GEOTECHNICAL SERVICES
RIO SALADO IMPROVEMENT

Near Farmer Avenue to McClintock Drive
Tempe, Arizona

Re Bed Material Gradation

Re Indian Bend Wash Drop Structure

Profile along
Grade Control Axis

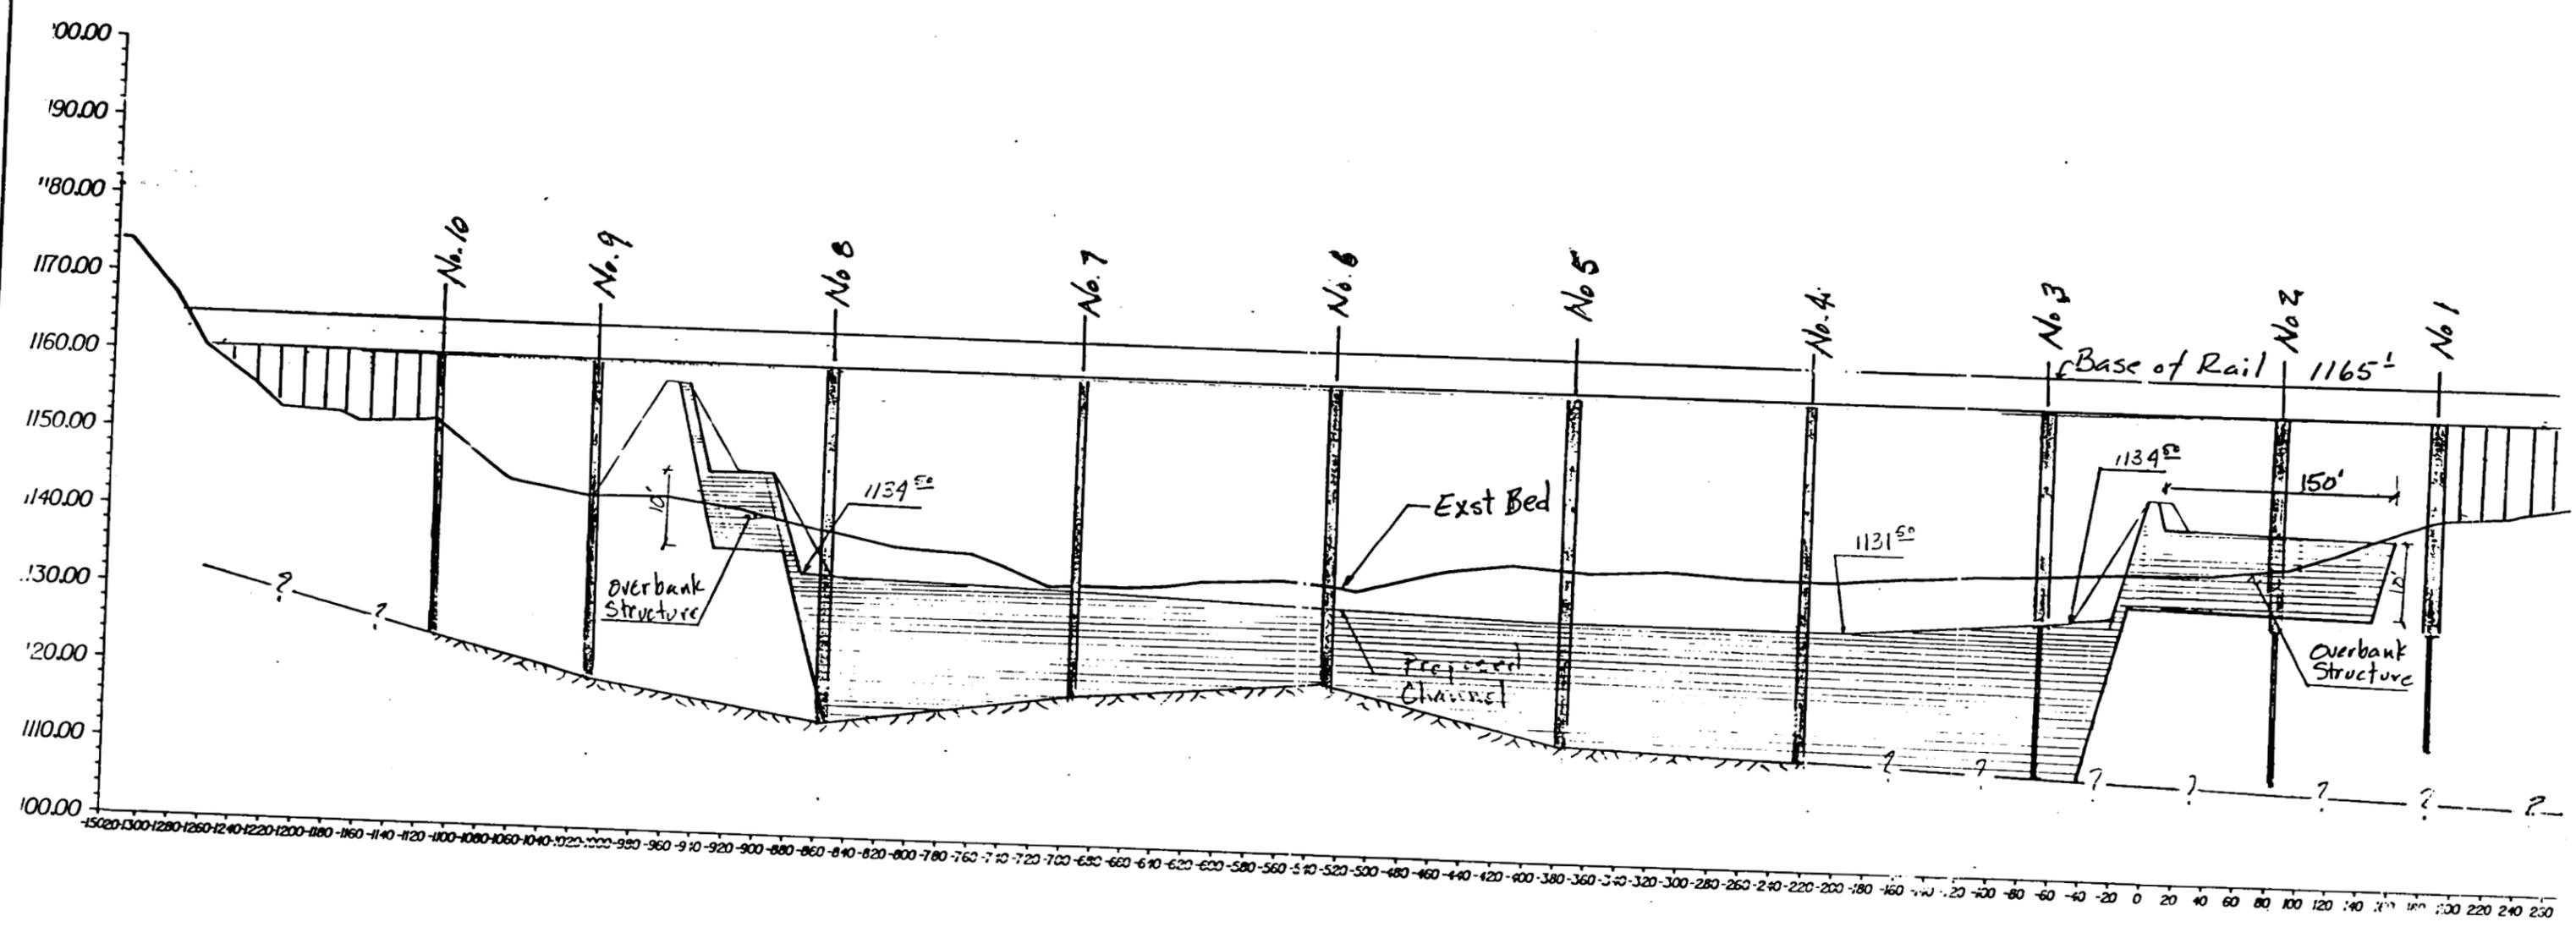
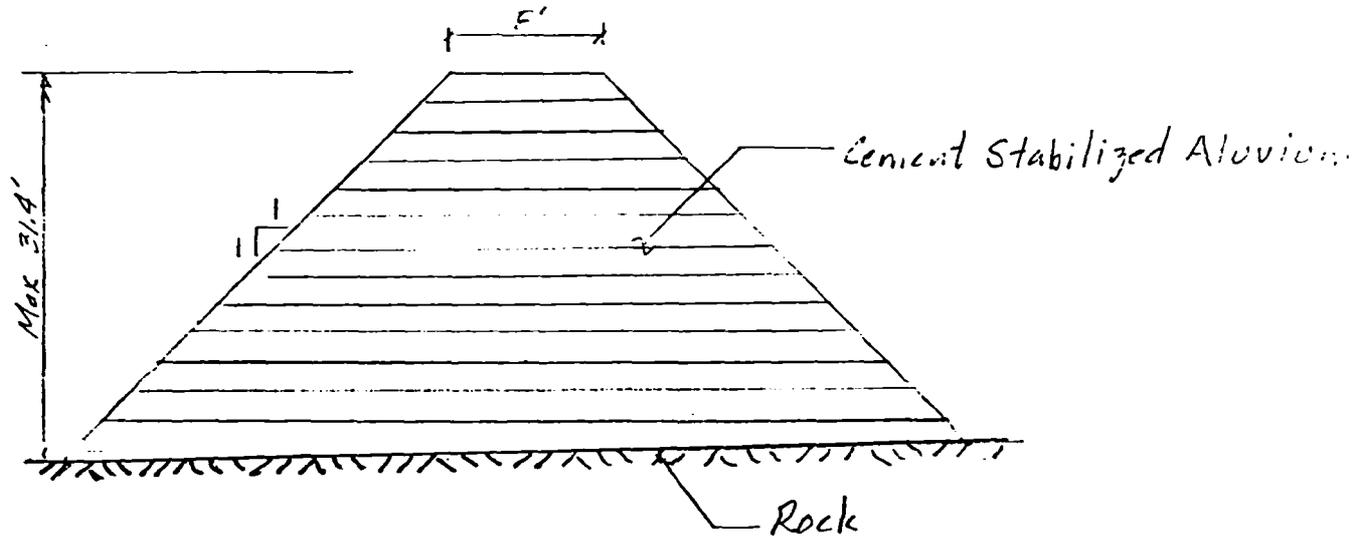
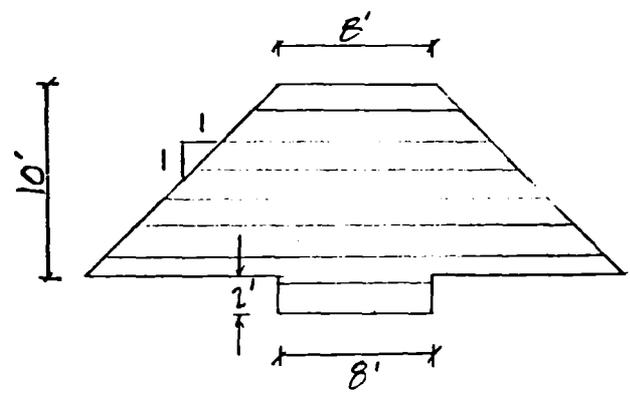
In the Salt River Working Group meeting conducted February 14, 1990, Tom Monchak (ADOT East Papago Management Consultant) requested additional information on the relocation of Grade Control No. 4. Attached is a profile for the proposed new location of this grade control showing existing ground, the proposed channel section, an estimate of the rock profile, and the location of SPRR bridge piers. Also attached is a plan for new location of the grade control structure.

ADOT would like to change order this relocation into the present construction contract. In order to do this, they will need to build not only the grade control structure but also the associated levee and bank stabilization downstream of the SPRR bridge which is planned for the Tempe Rio Salado Channelization.

IBW Drop Structure
Study of single drop

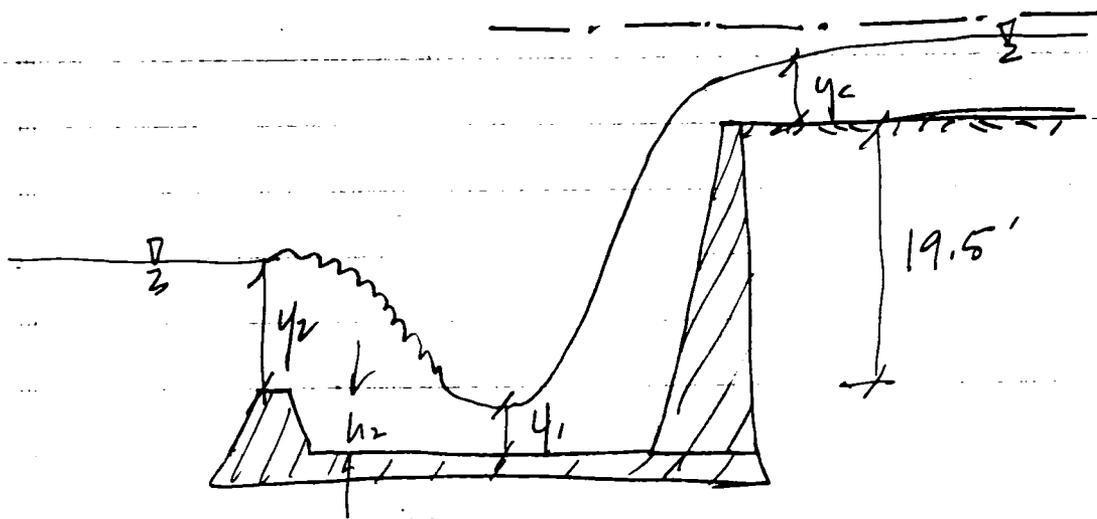
At the request of the Flood Control District, an alternative to the multiple drop design which was submitted in the initial design plans for the Rio Salado channelization has been prepared. A single drop design was studied. Assuming that the cement stabilized stilling basin can perform acceptably at the high velocities which result from a single drop, the drop structure will require 19 percent less cement stabilized alluvium (CSA) to construct. The velocity in the stilling basin is quite high for this design, 42 fps compared to 28 fps for the three drop design. For this velocity, a CSA stilling basing may erode severely during a flood event.

To check this, I called Ken Hansen at PCA. He said that based on experience of soil cement installations in Tucson, soil cement is abrasion resistant up to maximum velocities in the range of 15 to 18 fps. The maximum velocity can be increased if the +4 fraction of the mix is increased, creating a roller-compacted-concrete (RCC) type mix. He felt that velocities of 30 fps could be achieved with this type of mix. He felt that the Salt River gradation (he was familiar with the CSA design for the East Papago Freeway) would be similar to a RCC mix. He recommended the use of 18-inch high steps on the spillway face to promote air entrainment which would decrease problems associated with abrasion and negative pressures.

- This is 19% less compared to the 86.9 cY/ft for the triple drop.
- Velocity at base of drop is 50% higher
